Address: 37 Ice Pond Rd (L711)

C-B-L: #14-A-021

CHECK-LIST AGAINST ZONING ORDINANCE (2014-01737)

Proposed Use/Work - <sup>home</sup> construct 2 story with 1 story garage Single Family Dweller

**S1**

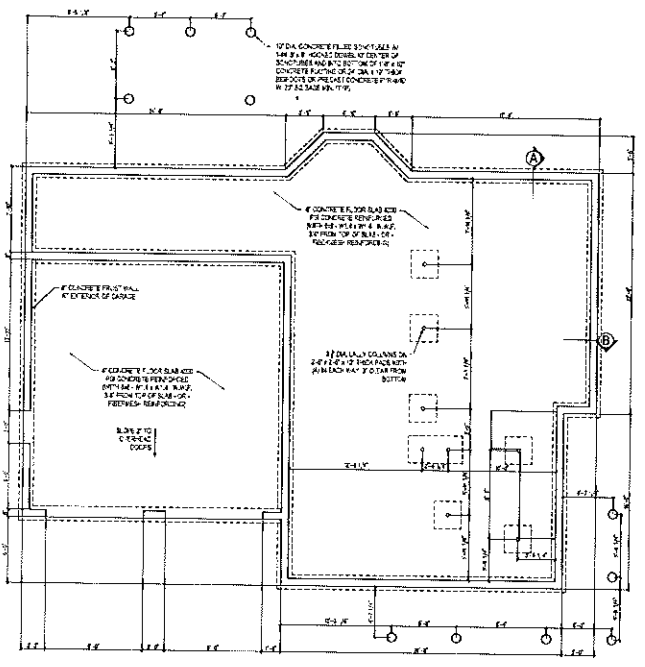
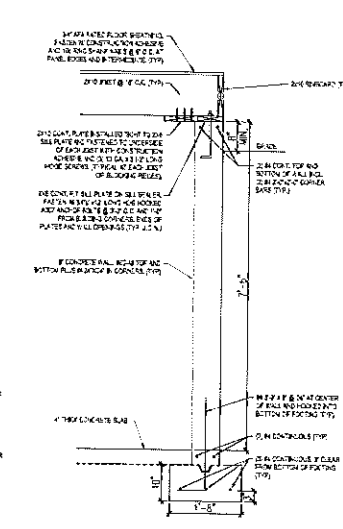
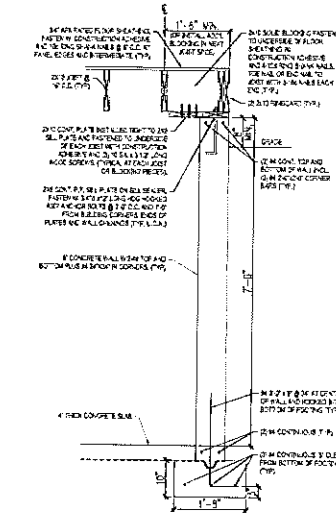
8/20/14  
Plan  
has diff rear  
Deck on top  
with tubes

I didn't see a copy of the HHE 200 attached. I also needed to see a revised foundation plan S1. That plan is showing a different rear deck configuration than any of the other plans. ALL the plans need to match.

I know you are on vacation this week, but I took a look at this new single family dwelling. I need a copy of the deed; since it has a leach field I need a copy of the HHE-200 State form. Also the foundation plan S1 is showing a different rear deck configuration than any of the other plans. That needs to be in compliance with the other renderings. We can discuss when you get back next week and have a chance to look at the plans.
